Trudeau Building Rehabilitation

Addendum #2: Historic Saranac Lake – Trudeau Building Rehabilitation
PROJECT LOCATION: Reconstruction at 118 Main Street, Saranac Lake, NY 12983
Issue Date: February 5th, 2023

Please be advised of the changes noted below to the Bidding documents and responses/answers to requests for information and questions received to date during the bidding period.

FENCE DETAIL

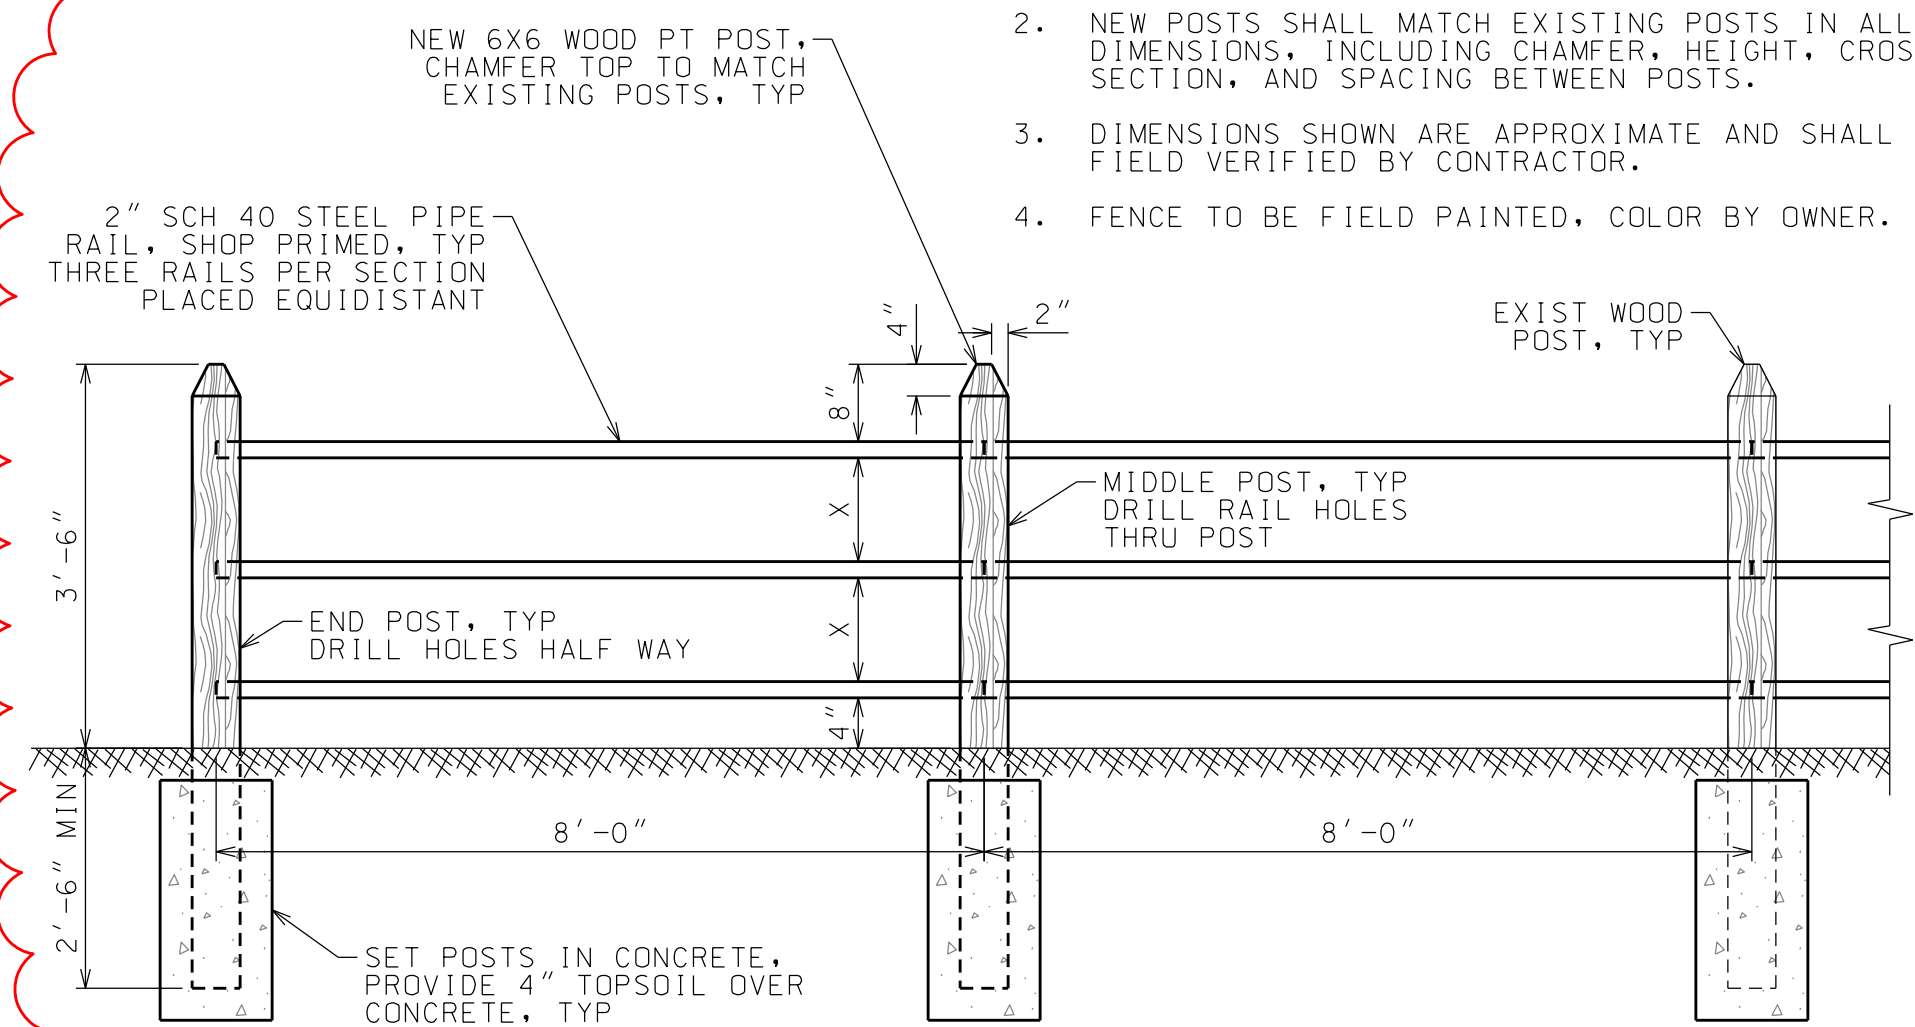
1. Fence detail added.

7 FIRE ALARM DIAGRAM
E7.0 SCALE: NO SCALE

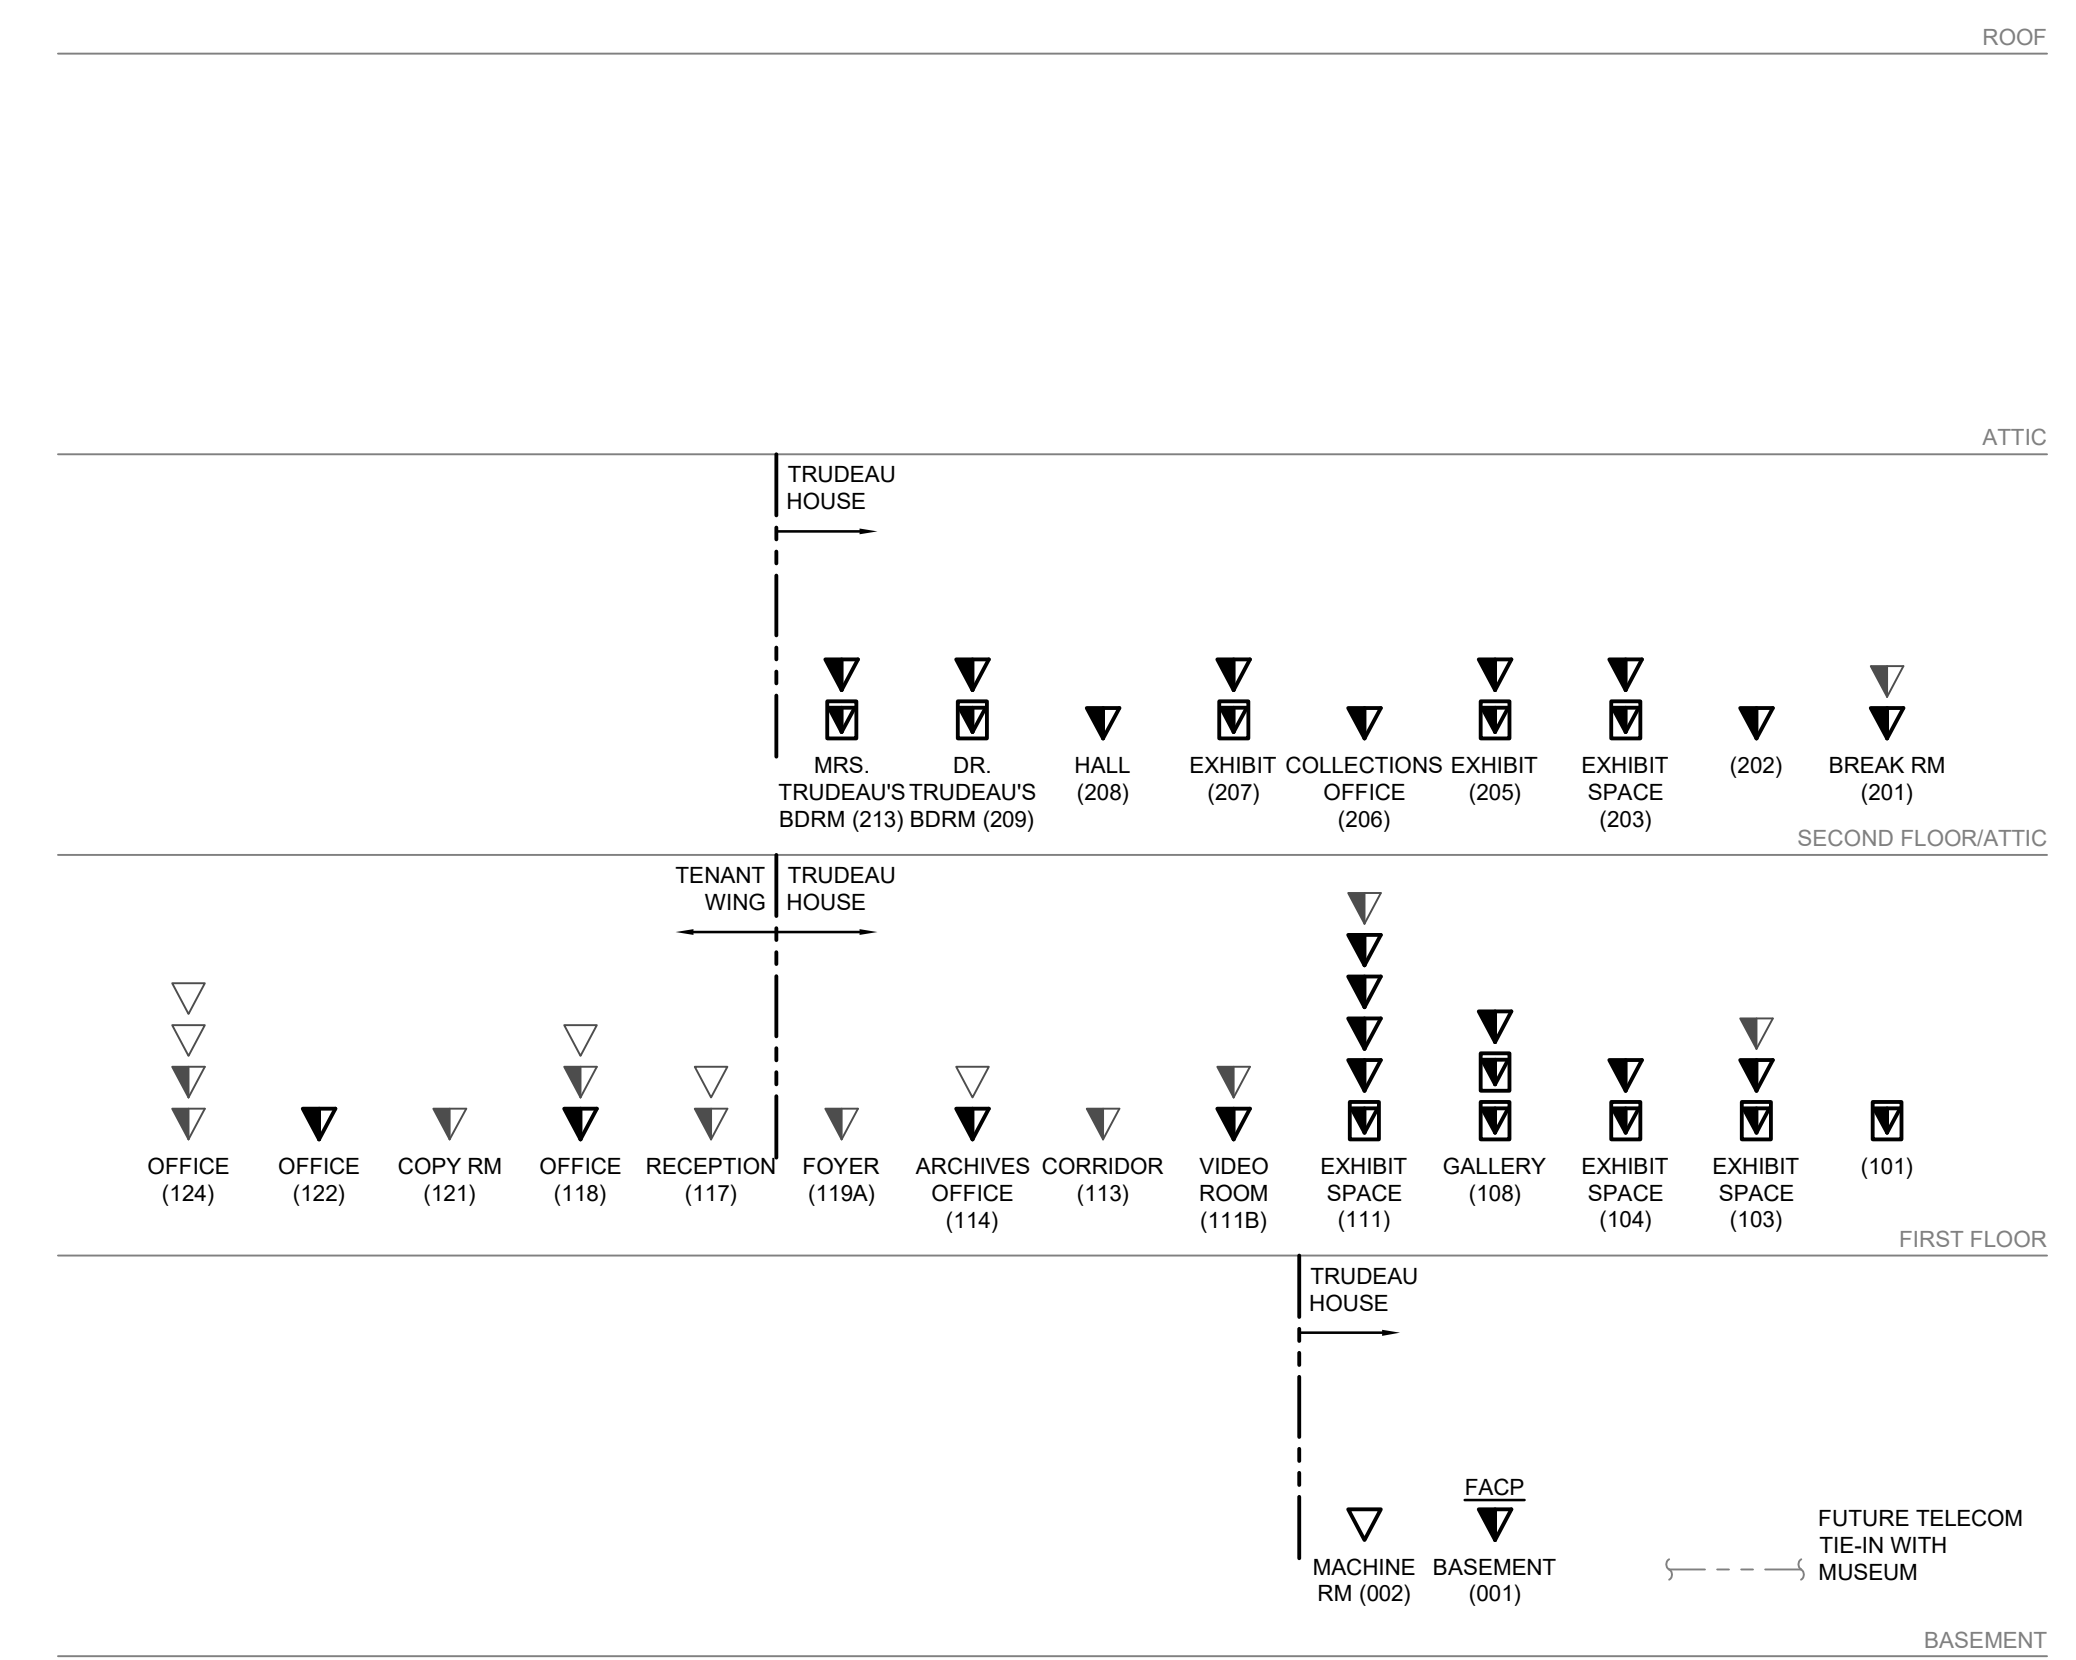
1. Fire alarm riser diagram updated to depict the pre-action fire sprinkler system releasing panel and devices.

1 PLUMBING DOMESTIC WATER RISER DIAGRAM
SCALE: NTS
P0.0

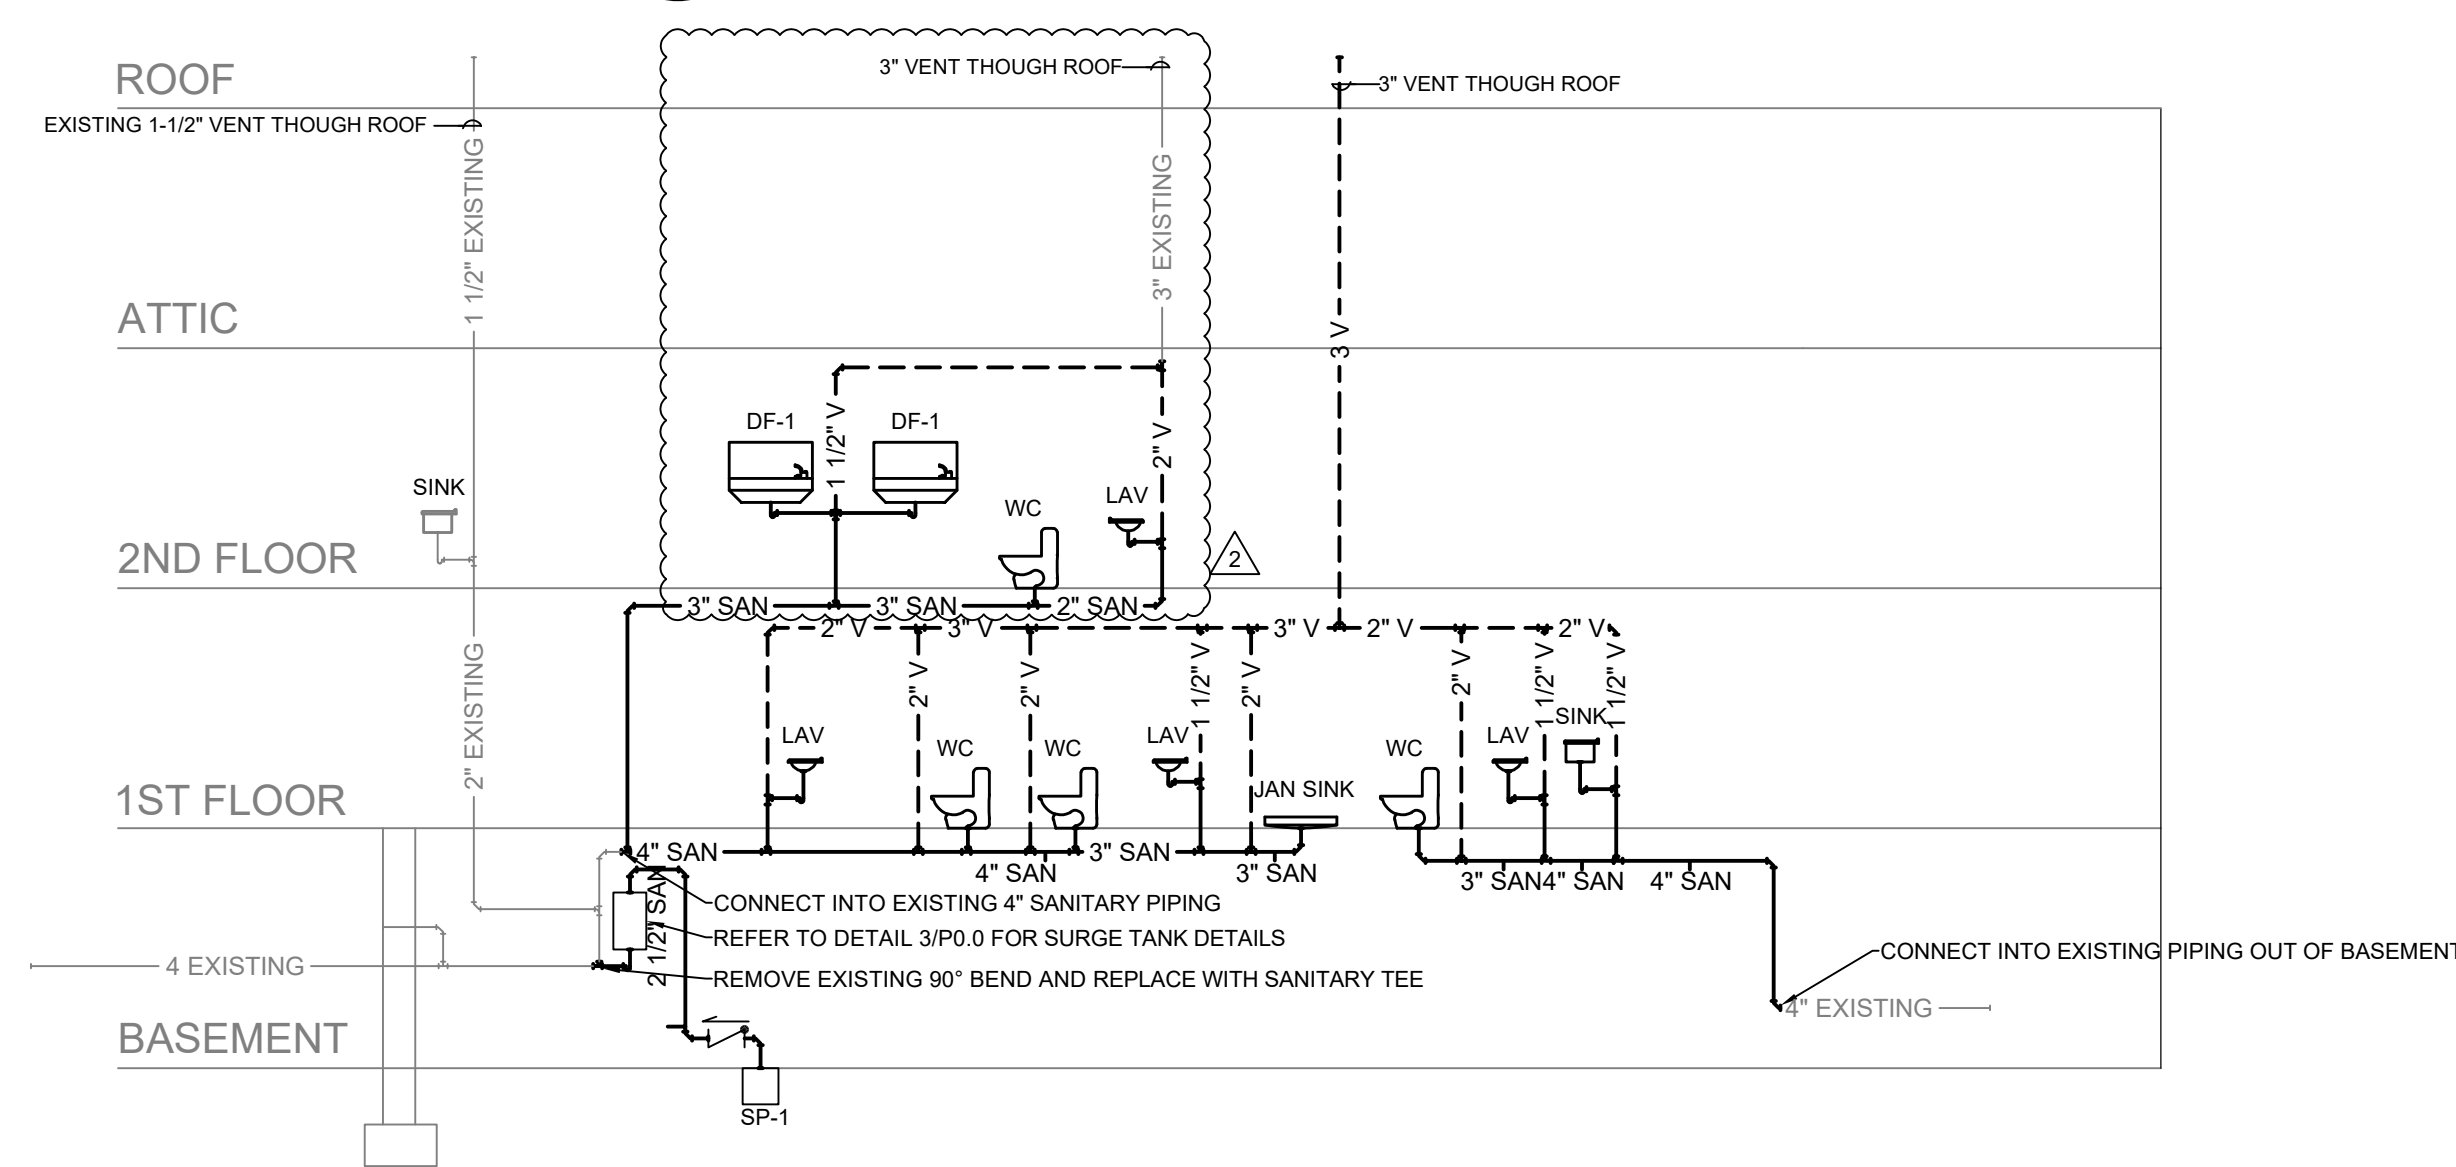
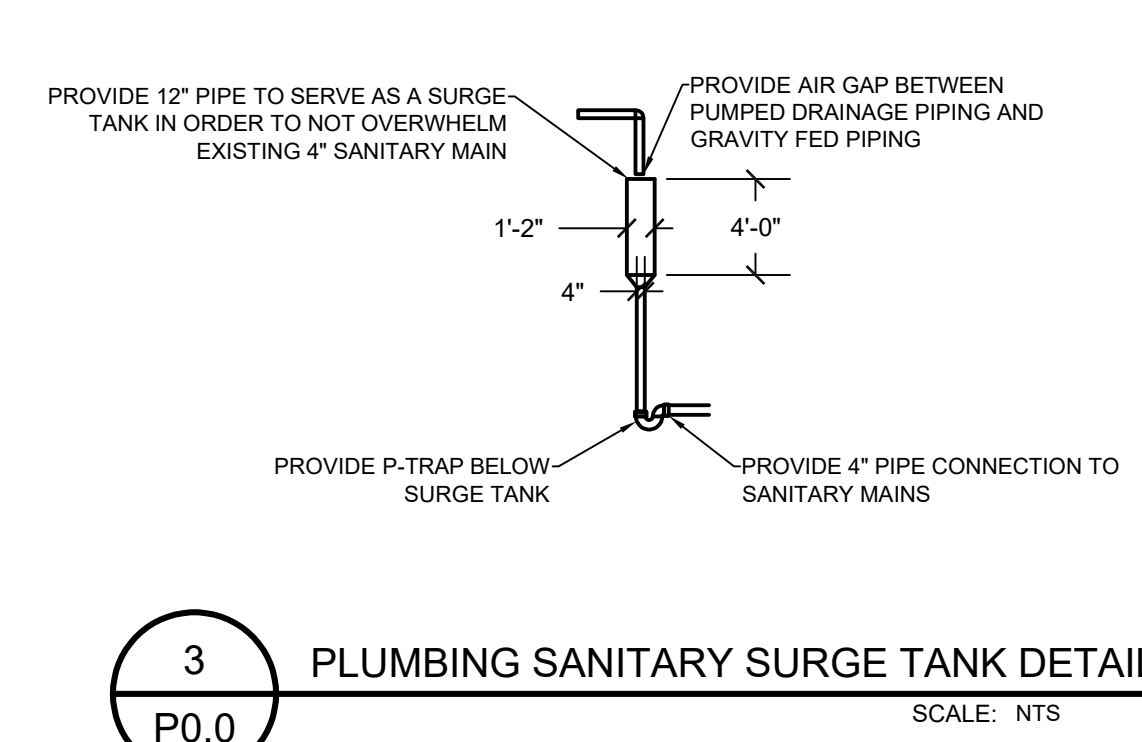
1. Adjusted the riser diagrams to account for modified piping layout.
